SUBJECT: Taurus Pedal Synthesizer Owners and Service Manual
Addendum, Manual 993-040749-001

NUMBER: 1178

This manual addendum requires that the information be revised on the pages noted prior to servicing the equipment. Also included are schematic updates and servicing guides. Please make these changes and add this addendum to the manual.

B. TAURUS SCHEMATIC UPDATES

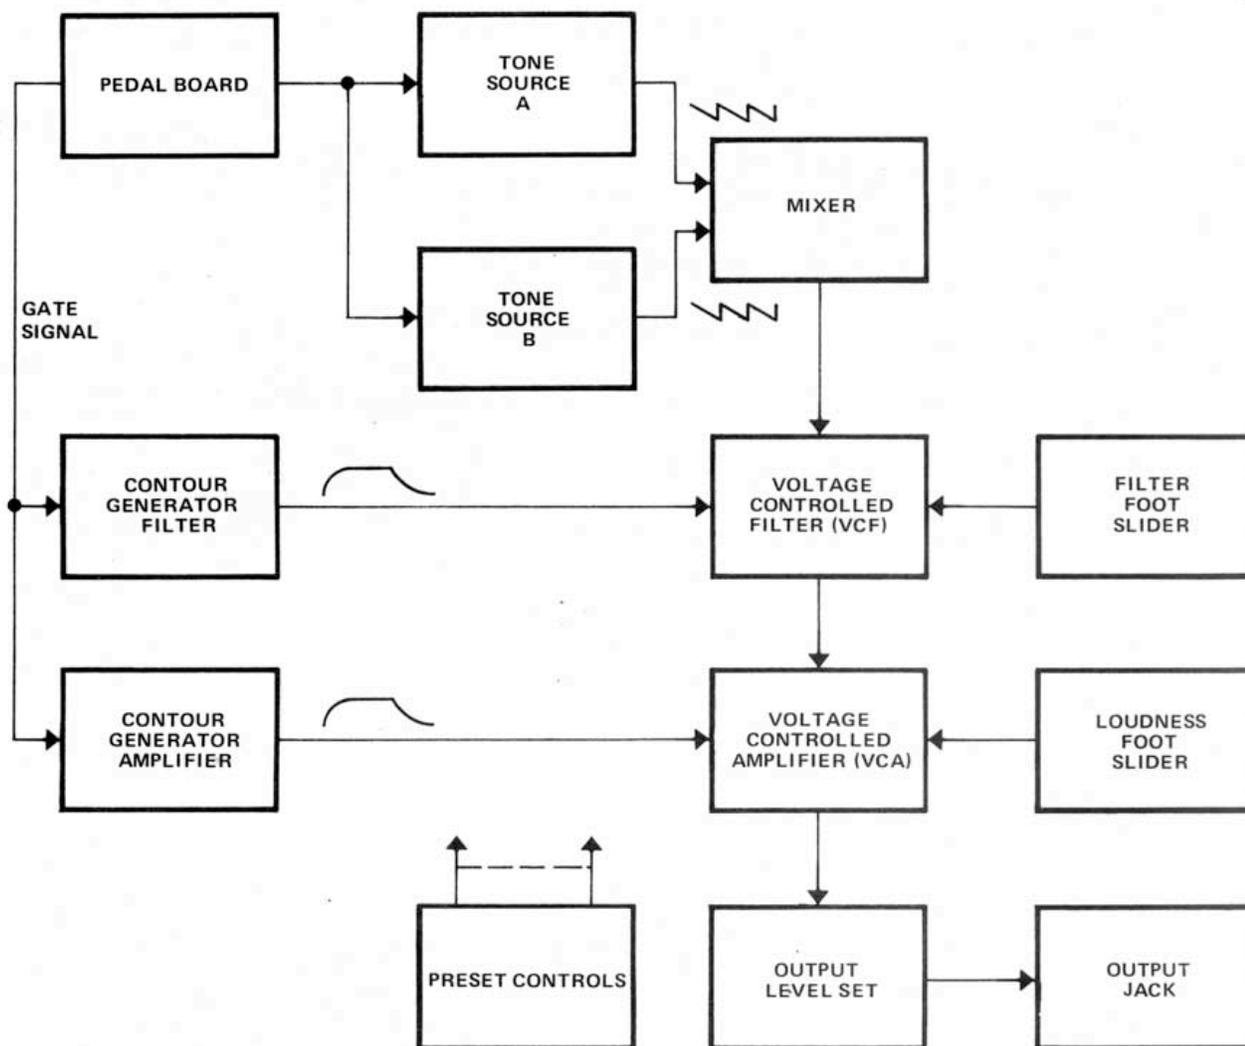
1. Delete note "Replace with 4066 if leakage occurs" located to the left of IC106, and replace with "Use only 4016".
2. Delete "+V" located to the right of pin 6 of Q101.
3. Delete "3.8V decay on", "0" off and "V+ decay off, 0V decay on" located to the left and right of IC904/(G38) respectively.
4. "Replace with 33K if output is distorted", located to the top right of IC801, refers to R808.
5. Delete "Emphasis Full Foot Filter-Off Cutoff-Off", located below Q501.
6. Change "A, B, C, D - ON ≈ 7.5V
OFF ≈ 0V"

Located below Q512 to read:

$\bar{A}, \bar{B}, \bar{C}, \bar{D}$ ON ≈ 0V
OFF ≈ -7.5V

7. CAUTION: Serial numbers below approximately 1150 do not have plated through holes; therefore, replaced components must be soldered on both sides of the printed circuit board.
8. When a component is replaced ALL FLUX MUST BE REMOVED to prevent board leakage.
9. Replace R117 (100K) with a 47K resistor if the trigger circuit is operating intermittently and the keyboard contacts have been determined not to be at fault.
10. "IC" refers to integrated circuits, resistor networks and integrated trimpots.
11. IC502, change 3821 to CA3046.
12. Resistor R312 below Q302, change V+ to V-.
13. Component Basing, change SG3821 to CA3046.
